CONSTRUCTION SUMMARY		RECEIVED	
Legacy Hill - Trinigroup Development Inc.		JUN 10 2024	
PURCHASERS: Zhuo Keng Henry HU and Cuixian WU		TEL:	
LOT / PHASE	REG. PLAN #	HOUSE TYPE	
105 / 1		Villa 6 Elev 3

Villa 6 36' Lot

Lot 105 Trinisgroup
Legacy

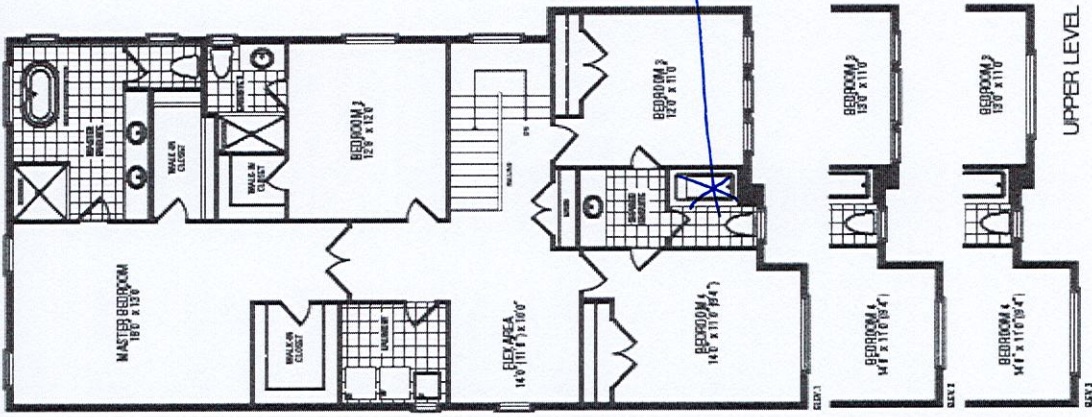
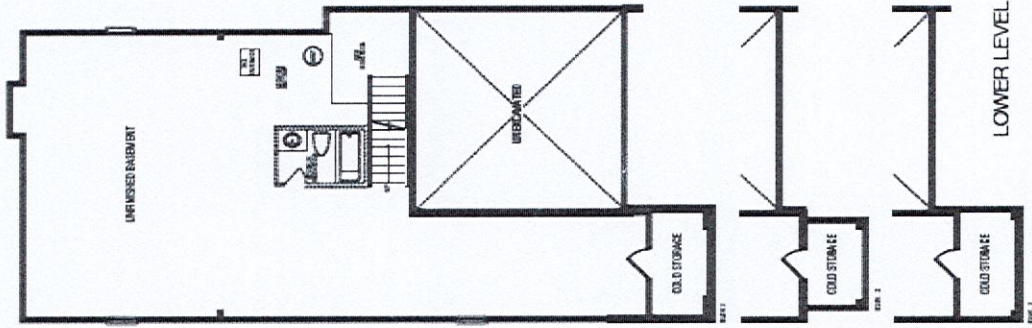
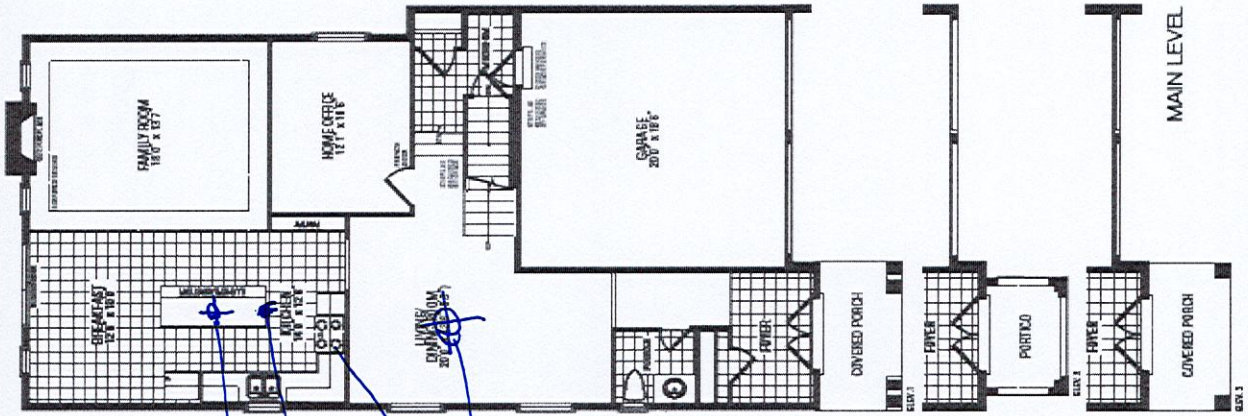
Center Light above
Island

Add Plug
to Island

Gas Line

Center Light between
Living | Dining

Tub to Shower
